Greystanes Industrial Estate Review of Stormwater and Groundwater Site Servicing Strategy

GHD has been requested by Dexus to review and assess the impacts that the master plan layouts proposed by Dexus have on the stormwater and groundwater servicing strategies adopted for the eastern portion of the Greystanes Industrial Estate development under Boral's approved Part 3A Concept Plan. This assessment will form part of Dexus' application under Part 3A of the EP&A Act for the development of the eastern portion of the Greystanes Industrial Estate.

FIGURE 2
STORMWATER CATCHMENT AREAS

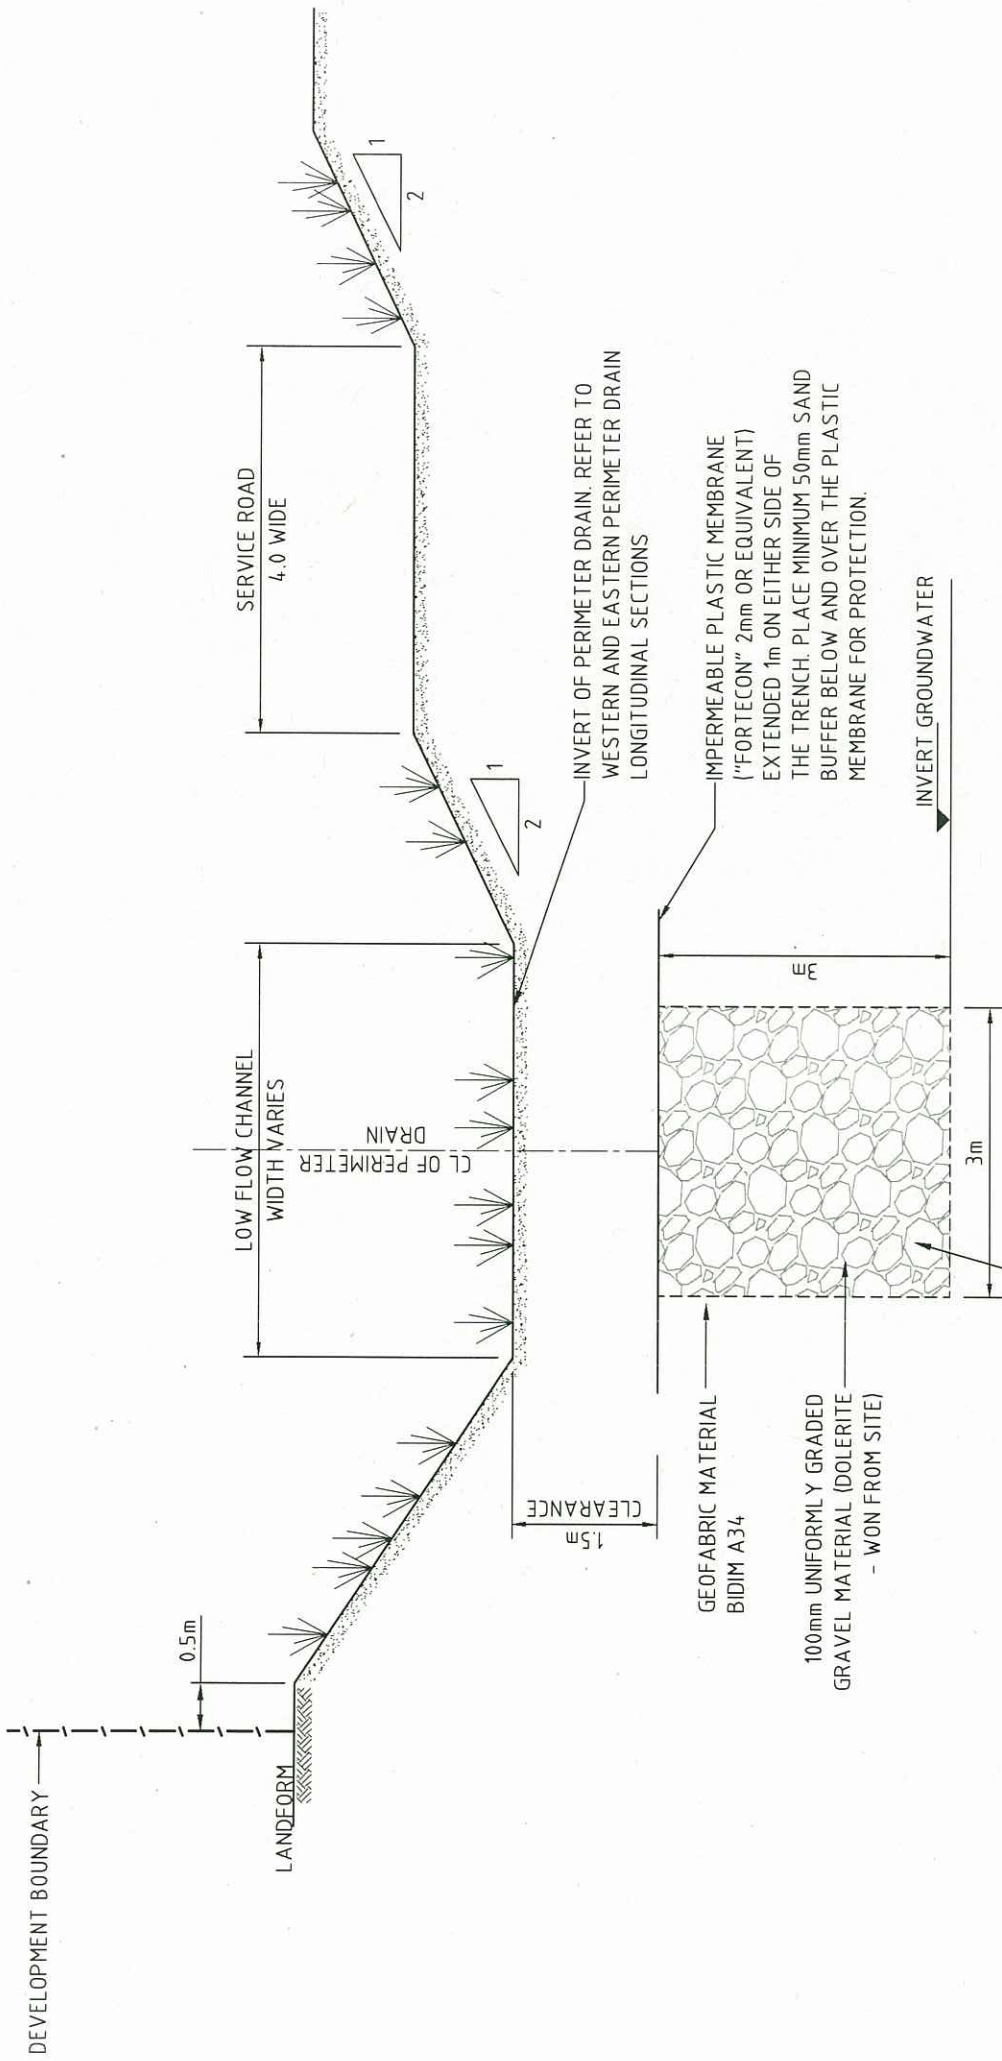
The approved concept plan strategy had assumed locations of stormwater discharge from the development into the eastern perimeter drain. Three main points of discharge were assumed and form the basis of hydraulic models for the design of the perimeter drains.

Refer to Appendix A for figure showing the location of discharge points based on Boral's Concept Plan.

Based on an assessment of Dexus' proposed master plans we believe that similar points of connections could be maintained. However, we note that the drainage system for buildings adjacent to the Spine

Road suits direct connections to the Spine Road. Controls must be in place to ensure that stormwater runoff from these building are directed towards the eastern perimeter drain.
